AGENDA OF THE LANDMARKS COMMISSION

WEDNESDAY, SEPTEMBER 16, 2020, 4:30 PM
Virtual Meeting. Public may join via Zoom.

Report to the
Landmarks Commission
of the City of Green Bay

(COA 20-25) Consideration with possible action on a design review for a replacement fire escape located at 126 N. Oakland Avenue

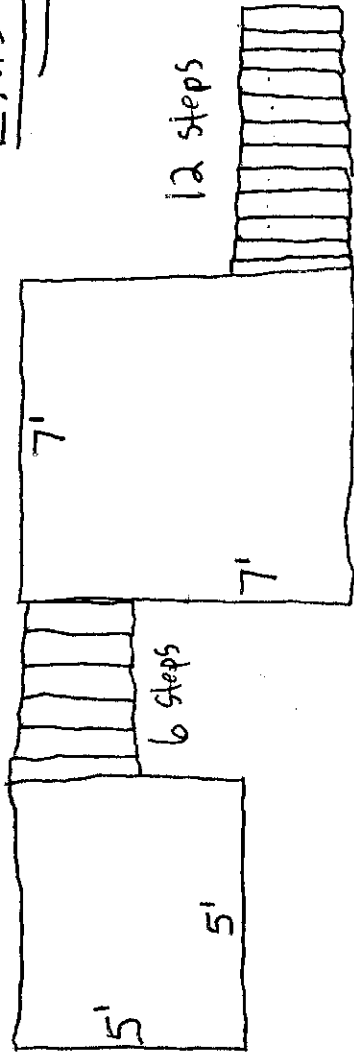
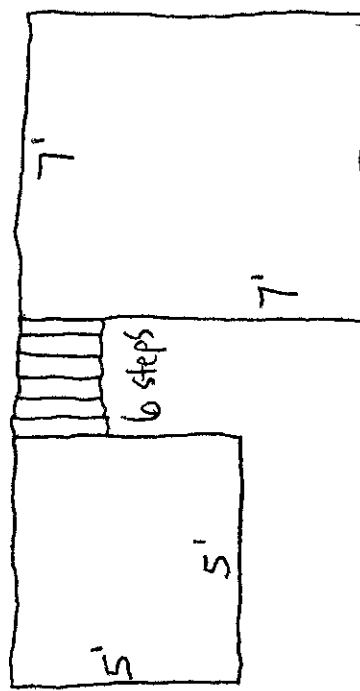
The owner proposes repair and replacement of portions of the existing rear fire escape and making an addition to the rear fire escape. LC staff notes that the existing fire escape was added in 1997 (per owner) and that the fire escape is not visible from the front of the house (perhaps minimally visible from an alley behind the house).

LC staff is recommending approval of the new fire escape arrangement as proposed. The new fire escape will have no impact to the historic structure of the house. The proposed fire escape is substantially similar to what is already present, it can be removed in the future with no damage to the house, it is not visible from the front, and it has no negative impact on the historic district.

1
A1.2 CLERESTORY PLAN
SCALE: ¼"=1'-0"

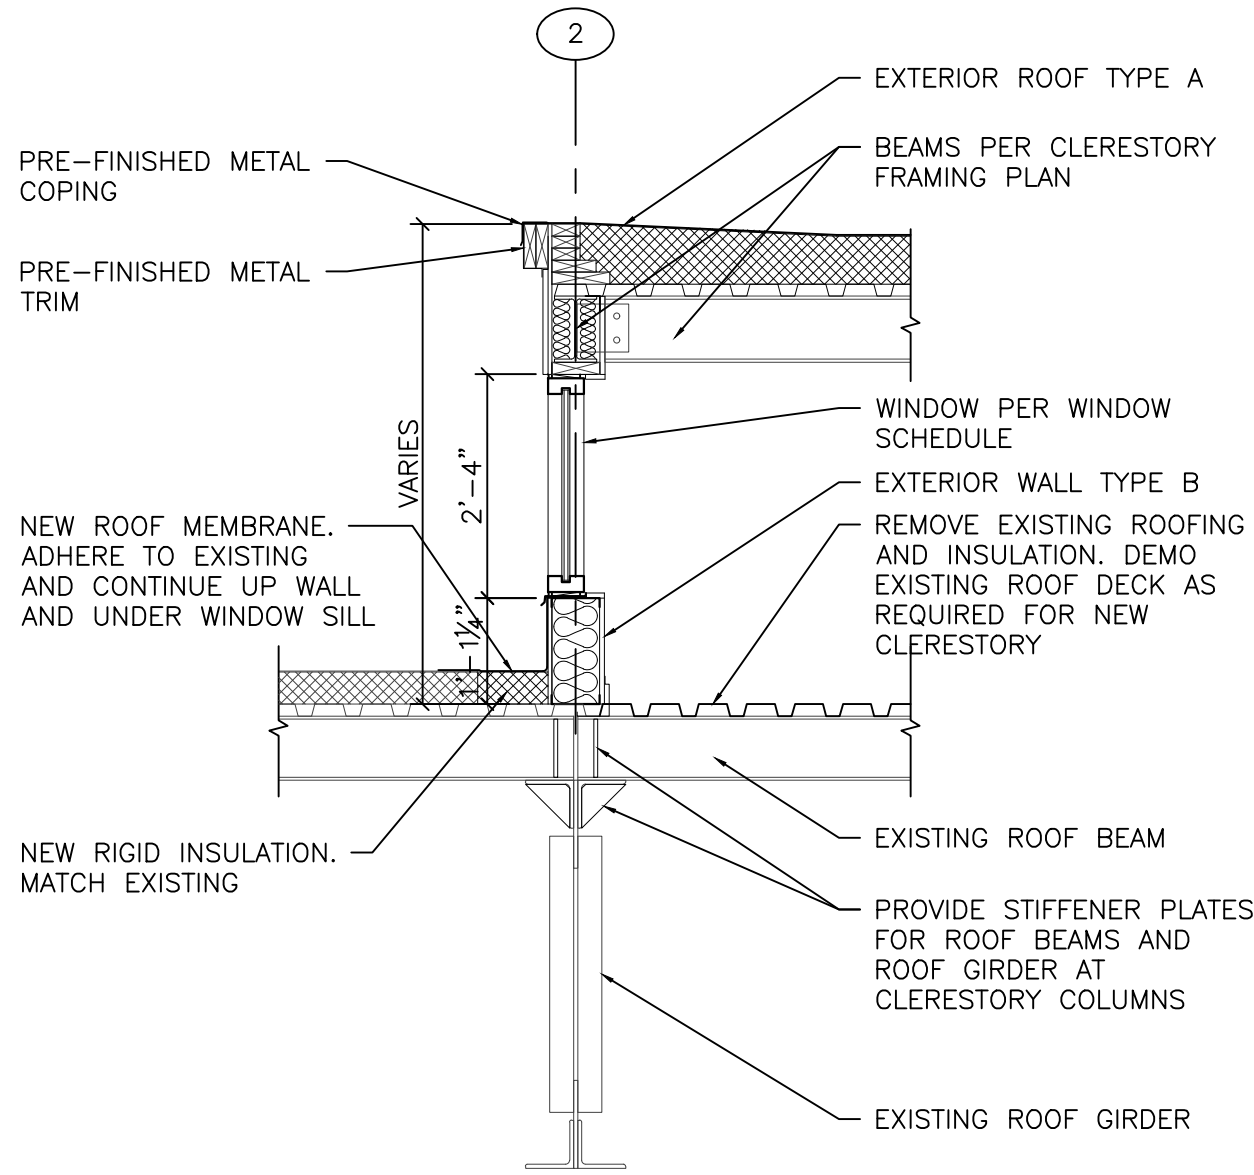
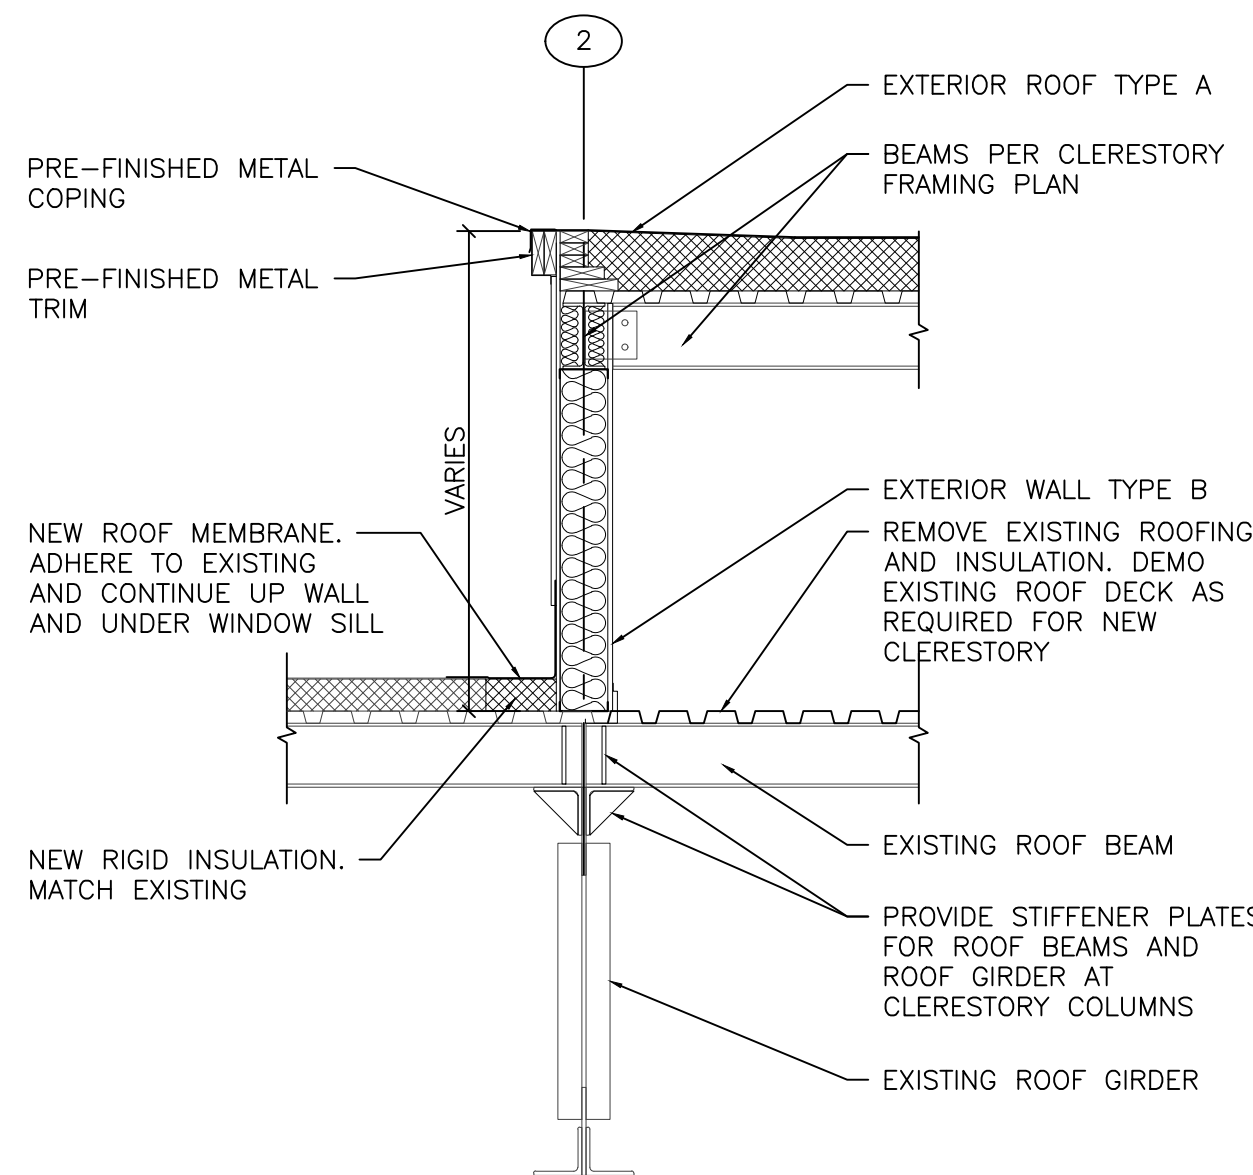
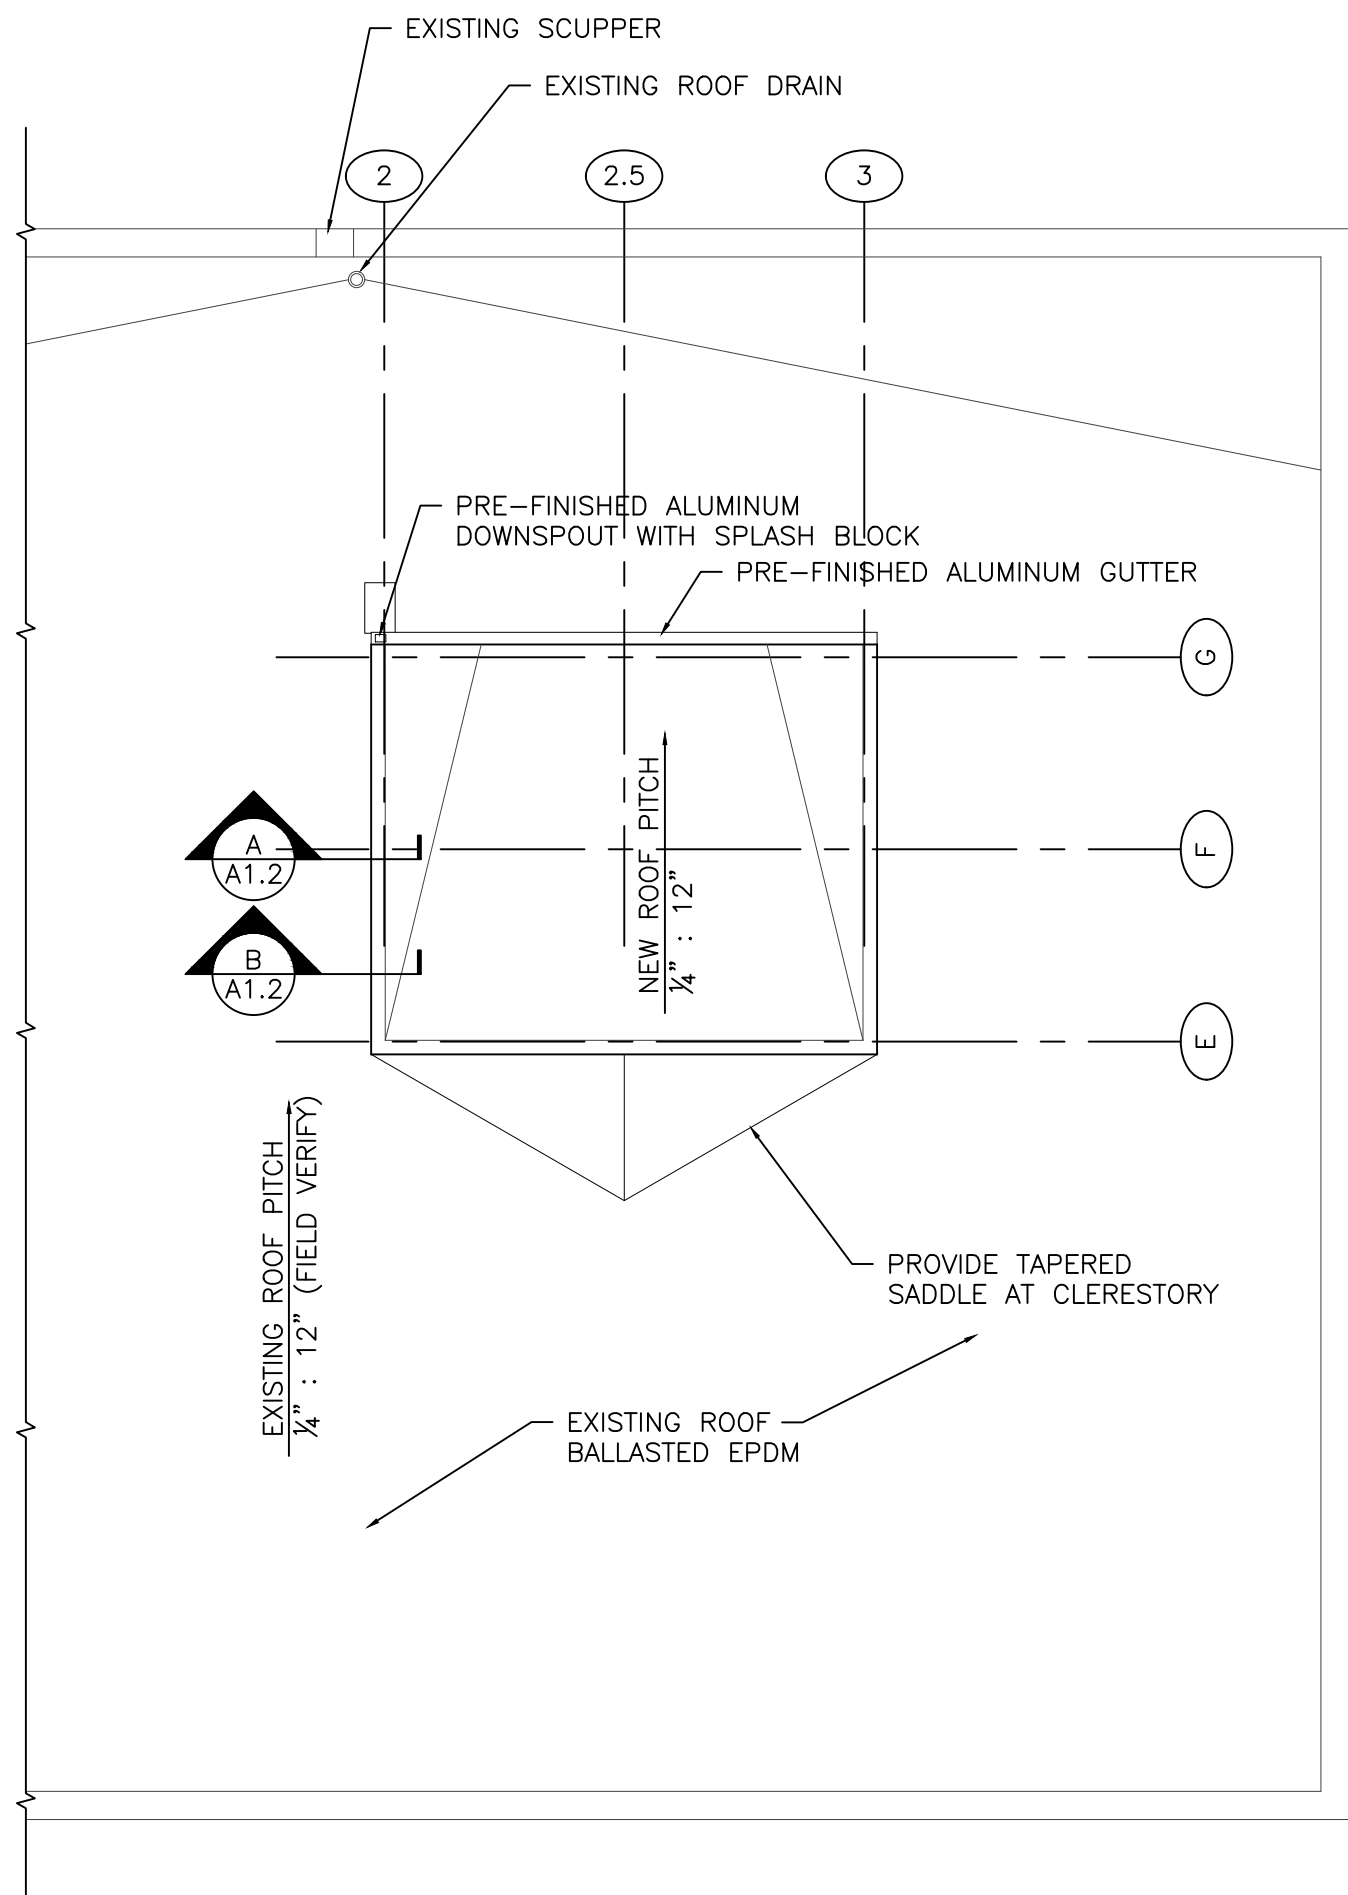
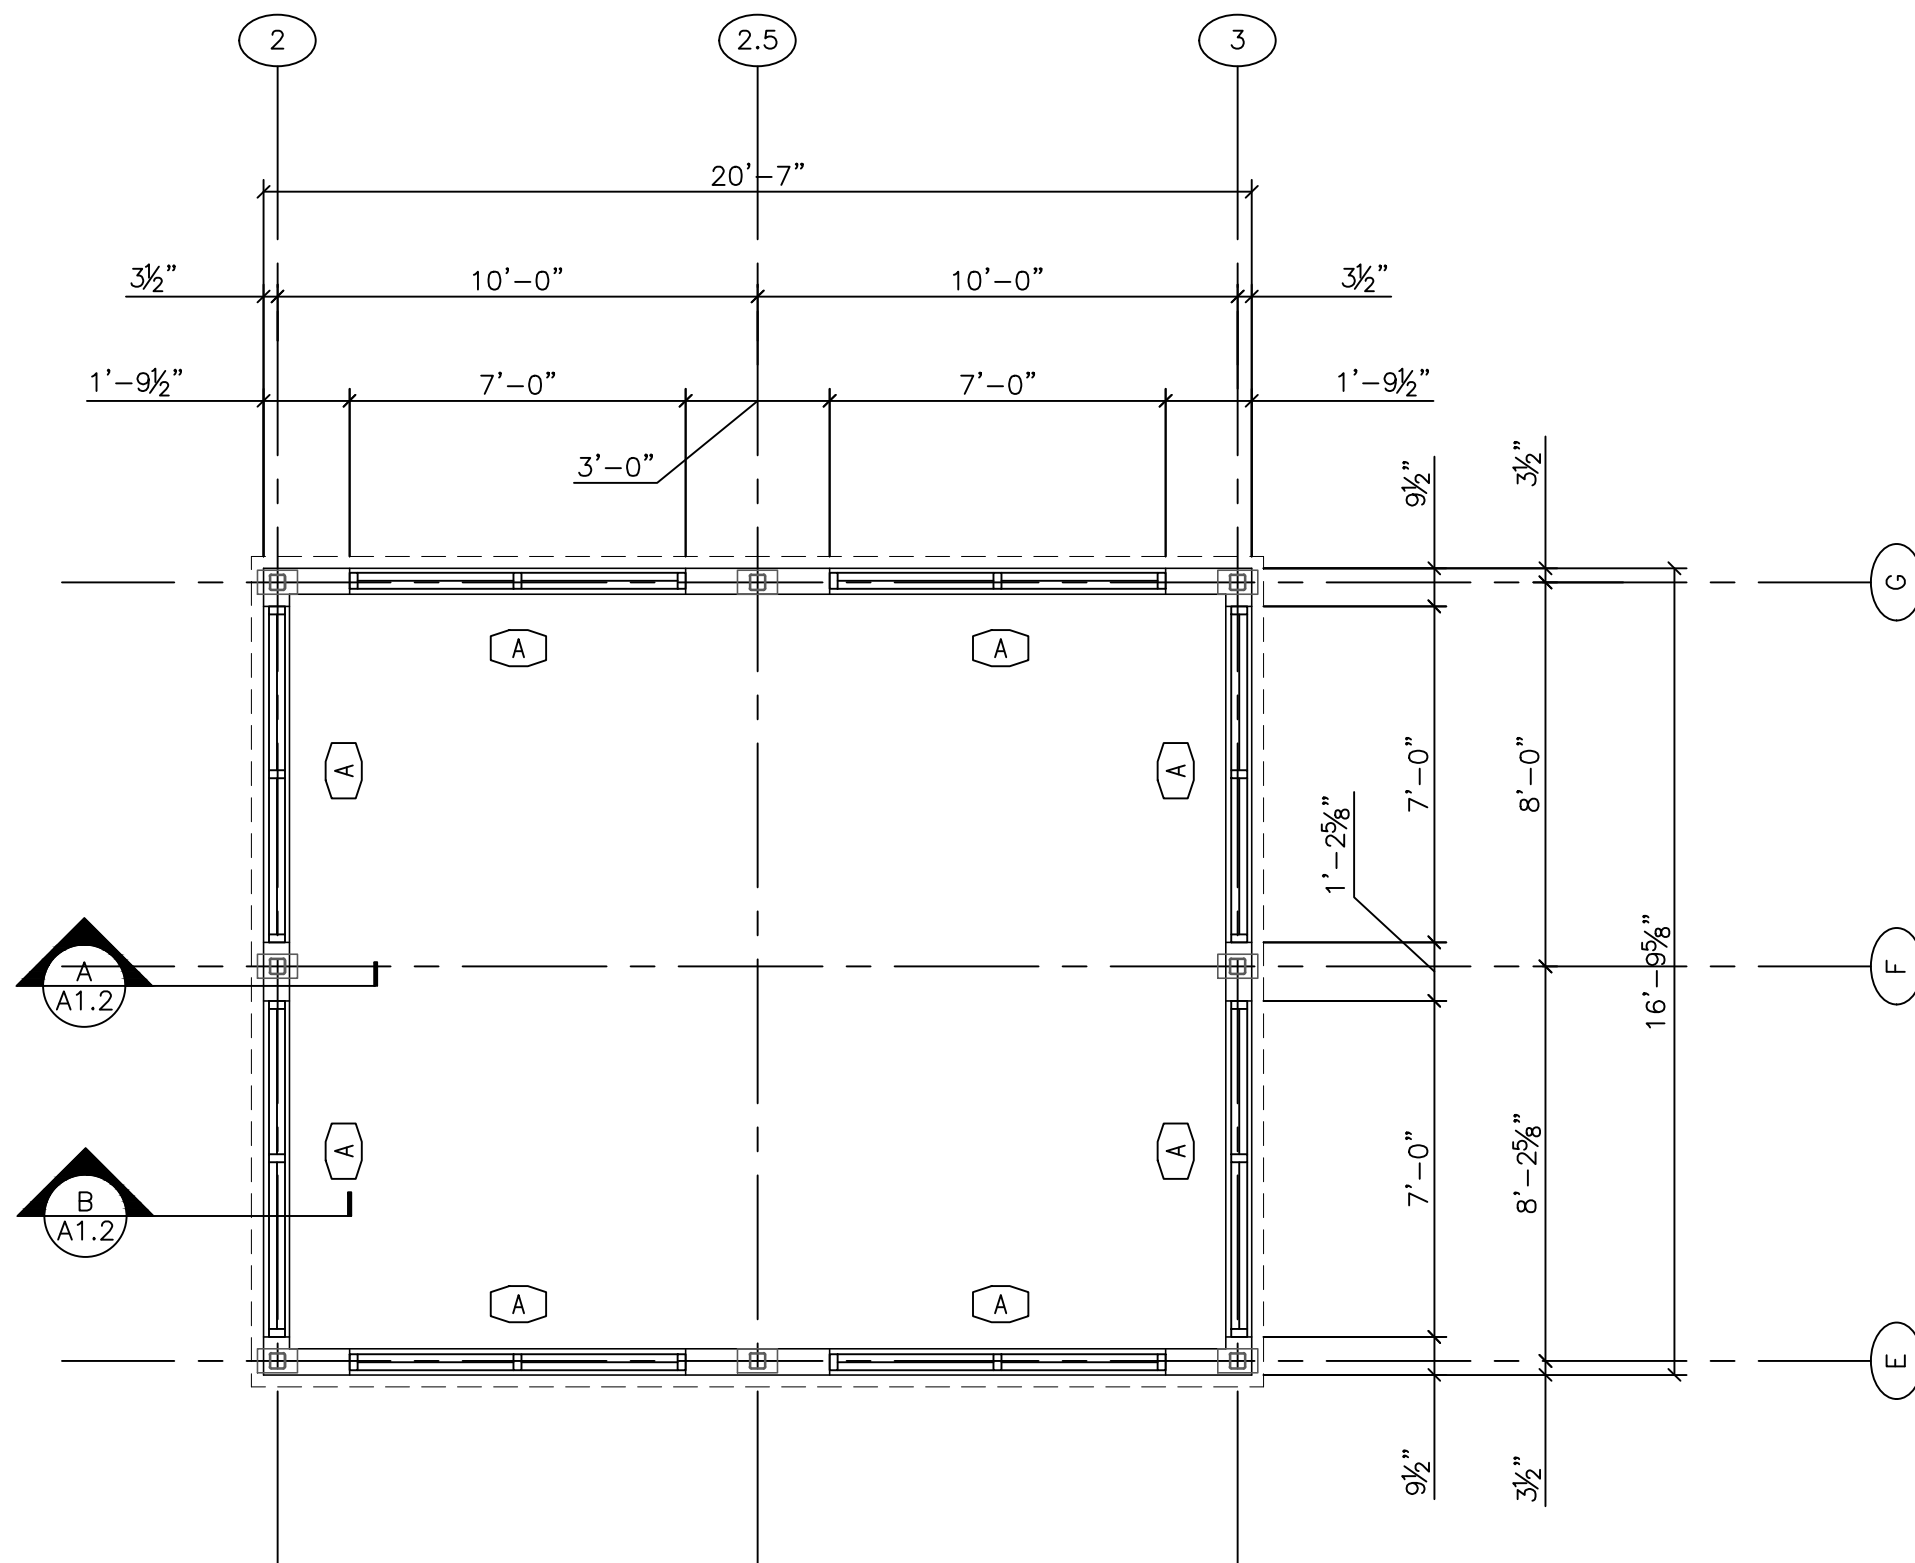
The owner also proposes to create a relatively short (less than 5 ft. tall?) clerestory window addition to the rooftop.

LC staff is recommending careful consideration of the proposed clerestory window. LC staff notes that

National Park Service Preservation Brief 14 is applicable, but was written with larger rooftop additions (habitable space) in mind. Regarding Preservation Brief 14, the proposed clerestory window appears to be neither explicitly compatible nor incompatible with the building at 110 S. Adams Street (“generally” inappropriate for one-story building, is it “minimally visible”?, etc). Regarding the Wisconsin Historical Society’s guidance, the clerestory window appears to lean towards being incompatible with the building because it could be considered “readily visible” from the sidewalk on the opposite side of the street and it is to be added to a building less than 3 stories in height. On a positive note, the proposed clerestory window is small in scale and has a compatible flat roof design. A shorter clerestory window would potentially alleviate concerns.
